MECKLENBURG COUNTY
DEPARTMENT OF ENVIRONMENTAL HEALTH

APPLICATION FOR SOIL INVESTIGATION

SITE INVESTIGATION REPORT
INDIVIDUAL SEPTIC TANK SYSTEM
WITH SUBSURFACE,
SOIL ABSORPTION,
EFFLUENT DISCHARGE

LOCATION OF LOT West Dixie Drive, Lot 10, Dixie Lane MHP

* See Diagram on Back (Include: Soil areas property lines roads, streams gullies rock areas fill areas, wells, water bodies, slope patterns etc

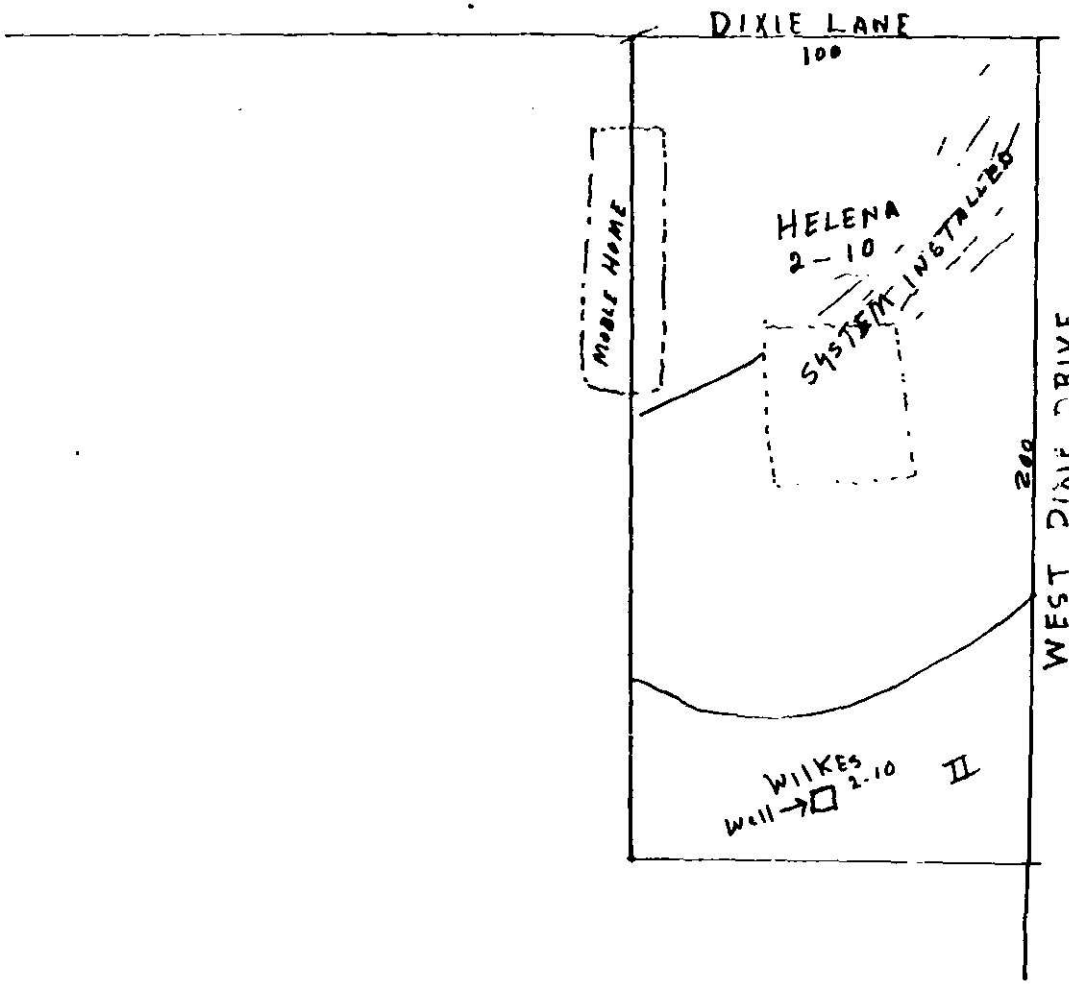
FACTORS	AREA 1	AREA 2	AREA 3	AREA 4
1. SLOPE (%)	S (PS) U — 2–10	S (PS) U — 2–10	S PS U	S PS U
2. SOIL TEXTURE (12-36 in.) (Sandy, loamy clayey, Note 2 1 Clay)	S PS (U) — CLAYEY 2-1	S PS (U) — Saprolite	S PS U	S PS U
3. SOIL STRUCTURE (12.36 in.) (Clayey Soils)	S PS (U) — MOSTLY MASSIVE	S PS (U) — Massive	S PS U	S PS U
4. SOIL DEPTH (In.)	S PS (U) — <48	S PS (U) — <48	S PS U	S PS U
5. RESTRICTIVE HORIZONS (In.) (Impervious Strata Rock)	S PS (U) — Clays	S PS (U) — Saprolite	S PS U	S PS U
6. SOIL DRAINAGE/GROUNDWATER (External & internal)	S PS (U) — SLOW	S PS (U) — slow	S PS U	S PS U
7. SOIL PERMEABILITY (Percolation Rate)	S PS (U) — SLOW	S PS (U) — SLOW	S PS U	S PS U
8. OTHER (Specify)	S PS U	S PS U	S PS U	S PS U
9. SITE CLASSIFICATION	UNSUITABLE	Unsuitable		
SOIL SERIES	HELENA	WILKES

Soil Structure Massive

Soil Permeability Unsuitable

Sites classified as Unsuitable are not acceptable for soil absorption of sewage effluent. However, if engineering, geologic, soil, and environmental studies indicate that a suitable septic tank system or a suitable alternate system can be expected to function satisfactorily, such sites may be re-classified as Provisionally Suitable. (Section 10 of the North Carolina Administrative Code 10 A,.1910)

If you desire to file for permission to install an "alternate or modified" system, you should present this office with your proposals in the form of plans and specifications. These would be reviewed and if it is found that the system may reasonably be expected to function satisfactorily, approval may be given on the execution by you of a "Septic Tank Agreement Form" available in this office.
